WESTERGATE STREET AND MEADOW WAY, WESTERGATE, WEST SUSSEX

Stage Road Safety Audit - Designers Response

PROJECT NO. 70013258

DATE: SEPTEMBER 2023

Copy of Drawing numbered 3258/GA/004 Rev C

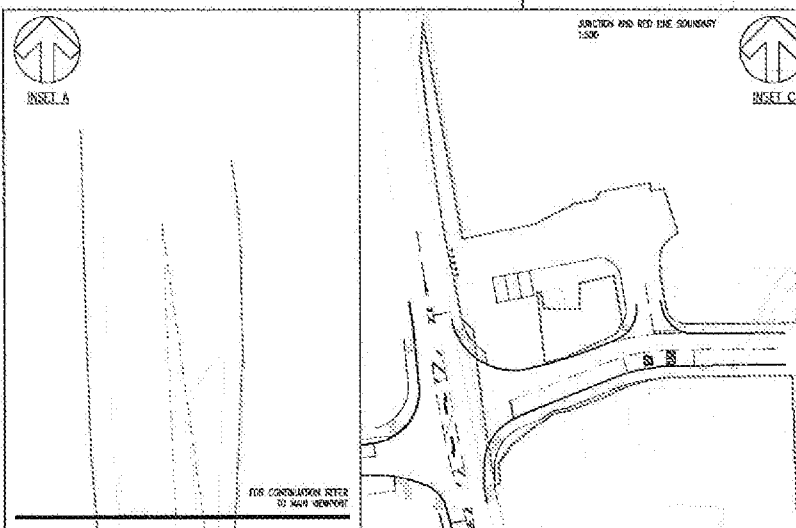
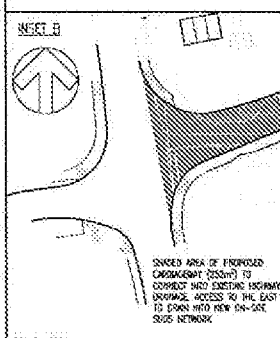
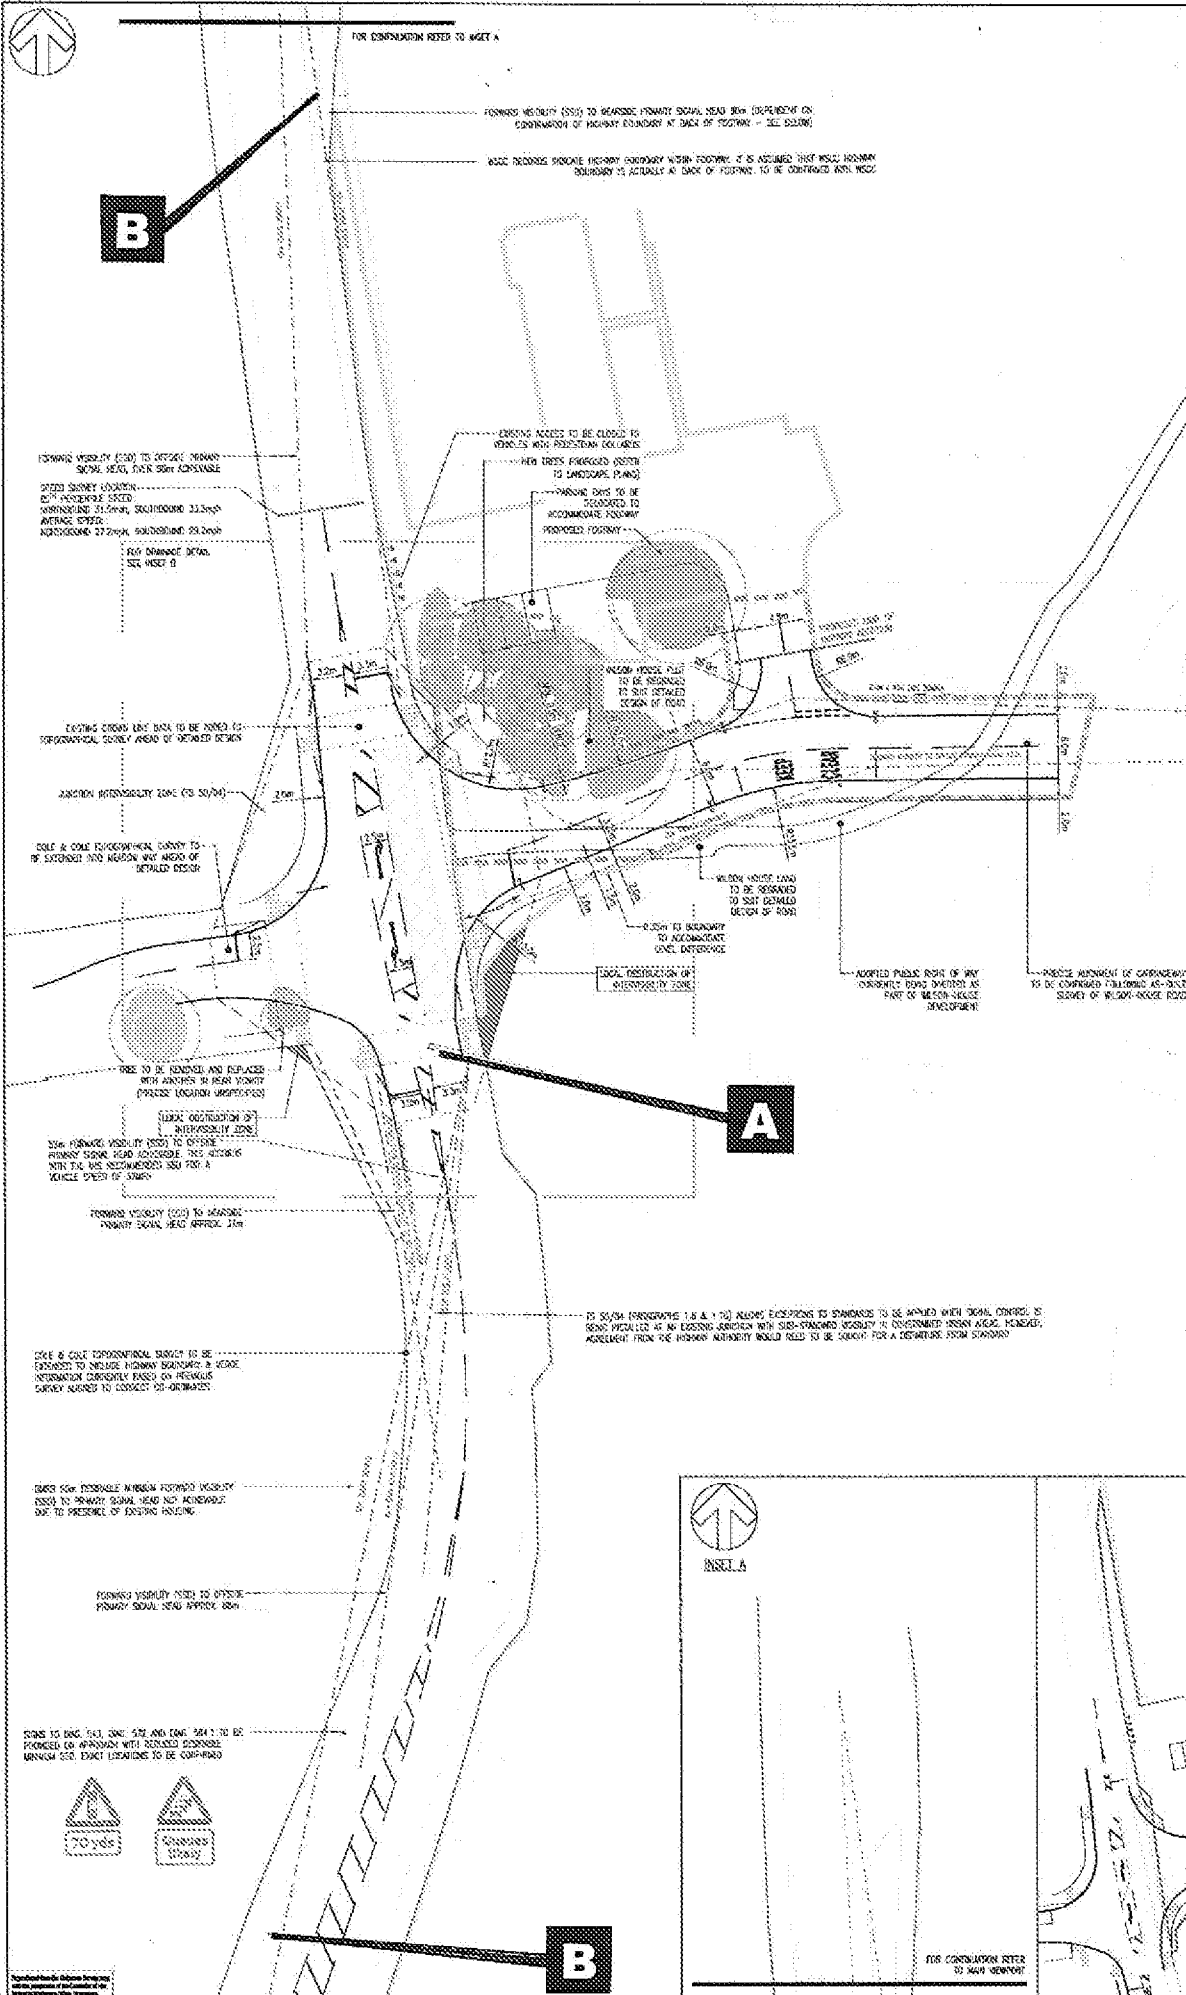
3.3.1 **PROBLEM** *(Drawing ref: 3258/GA/004 Rev C & /ATR/003 Rev B)*

The proposed junction design may need to be revisited with a view to investigating scope for shifting the northbound stop line and corresponding signal poles a few more metres further southwards of the currently shown position, which may also provide safer scope for large vehicles turning sharp left manoeuvre from the new site access road. A high level off-side secondary signal head may also need to be included.

3.5.1 **PROBLEM** *(Drawing ref: 3258/GA/004 Rev C)*

REF.	COMMENT	DESIGNERS RESPONSE
3.3.1	Location: (A) A29 Westergate Street, south of the junction with Meadow Way and the new access road. Summary: Risk of inadequate forward visibility of stop-line for waiting vehicles and/ or waiting pedestrians. Recommendation: The proposed junction design may need to be revisited with a view to investigating scope for shifting the northbound stop line and corresponding signal poles a few more metres further southwards of the currently shown position which may also provide safer scope for large vehicles turning sharp left manoeuvre from the new site access road. A high level off-side secondary signal head may also need to be included. The yellow box markings indicated for the southbound traffic flow may also need to be extended to also include the northbound through flows. It is further recommended that high friction surfacing should also be incorporated on the northbound approach for sufficient length to mitigate the potential northbound vehicle queuing and risk of failure to perceive the red lights associated with the signalised junction and pedestrian crossing facility.	<i>It has not been possible to relocate the A29 northbound stop-line further southwards due to the need to maintain junction inter-visibility between stop-lines. While full inter-visibility as measured in DMRB is not possible the current arrangement allows visibility between the A29 northbound and site access stop-line, which includes the extent of access road pedestrian crossing. Moving the A29 northbound stop-line further south would remove visibility between stop-lines.</i> <i>The ability to relocate the northbound stop-line further south is also limited by the residential property located on the south eastern corner of the junction, whereby such a modification would obstruct the visibility between the A29 northbound and site access road stop-line.</i> <i>The option of relocating the access road stop-line slightly westwards (to extend the limits of the junction inter-visibility further southwards on the A29 northbound) has been explored but this is not possible due to proximity of the pedestrian crossing on the access road to the A29 southbound lane.</i> <i>High friction surfacing will be incorporated into detailed design stages of the proposed junction.</i>

REF.	COMMENT	DESIGNERS RESPONSE
3.5.1	Location: (B) A29 Westergate Street, at the approaches to the new signalised junction. Summary: Risk of failure to perceive new junction control ahead. Recommendation: The proposed signing works should also include appropriate temporary warning signs to TSRGD Diagram 7014 for a slightly longer period of say six months to alert visiting drivers to the new signalised junction.	<i>It is agreed that temporary warning signs should be erected but timescales will need to be agreed with WSCC as part of the technical approval process.</i> <i>The junction design also includes provision of signage to Diagrams 543, 572, 584.1 of TSRGD to warn drivers on the A29 northbound of the traffic signal junction. This should help non-local drivers identify the junction ahead.</i>

SCALE @ A1:	1:250	CHECKED:	LRB	APPROVED:	LRB
CAD FILE:	3258-GA-004.DWG	DESIGN-DRAWN:	MFB	DATE:	December 2022
PROJECT NO:	70013258	DRAWING NO:	3258/GA/004	REV:	F
© WSP Group Ltd

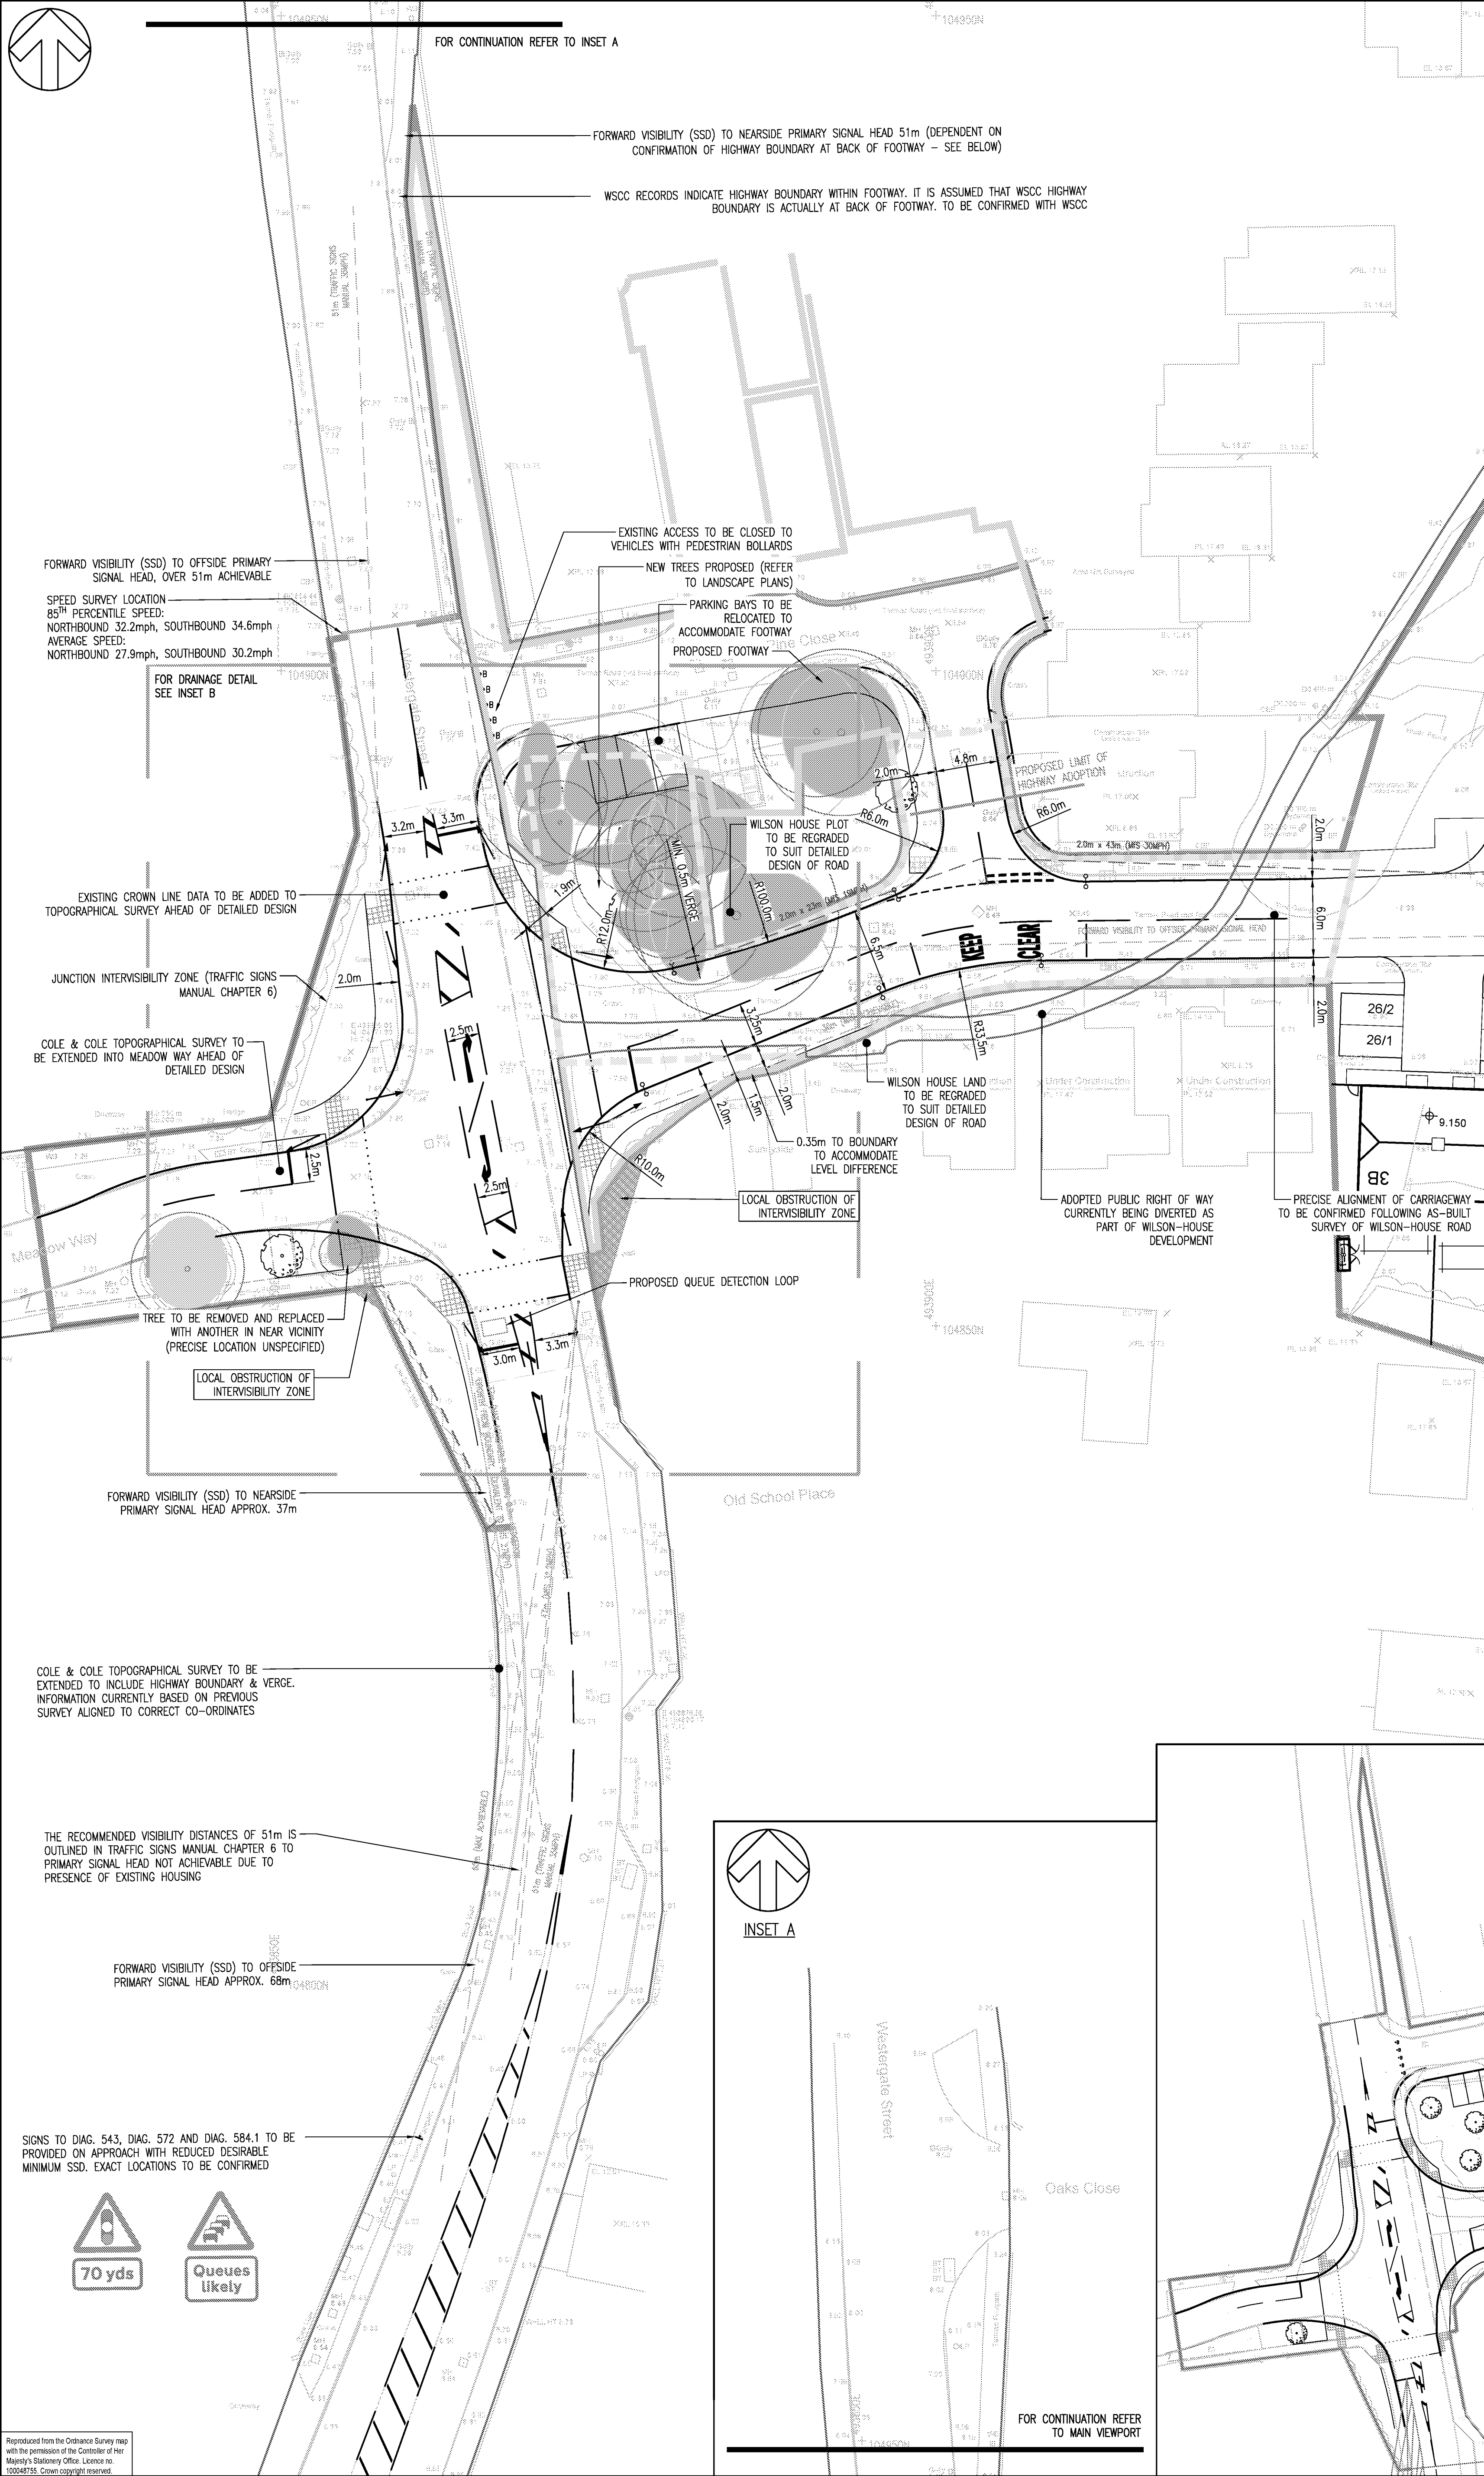
- 2.2.1. Locations 1 & 2 - On the south eastern and north western corners of the proposed traffic signal junction (Drawing No. 3258/GA/004 Rev F).

- 2.2.2. An identified Departure from Design Standard with regard to junction intervisibility could lead to a potential increased risk of side impact vehicular collisions occurring or nose to tail shunt type collisions occurring, whereby vehicle occupants could sustain personal injury.

- 2.2.6. Location 3 - On the north bound approach to the proposed traffic signal junction (Drawing No. 3258/GA/004 Rev F).

- 2.2.7. An identified Departure from Design Standard with regard to forward visibility and stopping sight distance on the A29 north bound approach to the traffic signal junction could lead to a potential

- 2.2.13. Location 4 - On the north bound approach to the proposed traffic signal junction (Drawing No. 3258/GA/004 Rev F).

- 2.2.14. An identified Departure from Design Standard with regard to forward visibility and stopping sight distance to the back of queuing traffic on the A29 north bound approach to the traffic signal junction could lead to a potential increased risk of nose to tail shunt type collisions occurring between a leading and any following vehicles, whereby vehicle occupants could sustain personal injury.

- 2.2.20. On the south bound approach to the proposed traffic signal junction (Drawing No. 3258/GA/004 Rev F).

- 2.2.4. Problem accepted, noting that a ‘Keep Clear’ box markings have been included on the westbound approach. This is shown on the updated Site Access General Arrangement Drawing LAW-WSP-ZZ-ZZ-C-DR-0006.
- 2.2.5. Recommendations related to the provision of an all-red detector and use of MOVA detection are also accepted and will form part of the detailed design process for the junction.

- 2.2.10. Recommendations regarding signage is accepted. The provision of signs 543 and 584 are included as part of the proposed site access junction. This is shown on Drawing XXXXXXXX.
- 2.2.11. Recommendations regarding provision of an offside primary signal head is also accepted as shown on Site Access General Arrangement Drawing LAW-WSP-ZZ-ZZ-C-DR-0006.
- 2.2.12. Recommendations regarding the use of high coloured surfacing and traffic signal operation are also accepted and will be considered further during detailed design.

- 2.2.17. Recommendations regarding signage is accepted. The provision of signs 543 and 584 are included as part of the proposed site access junction. This is shown on Drawing XXXXXXXX.
- 2.2.18. Recommendations regarding provision of an offside primary signal head is also accepted as shown on Site Access General Arrangement Drawing LAW-WSP-ZZ-ZZ-C-DR-0006.
- 2.2.19. Recommendations regarding the use of high coloured surfacing and traffic signal operation are also accepted and will be considered further during detailed design.
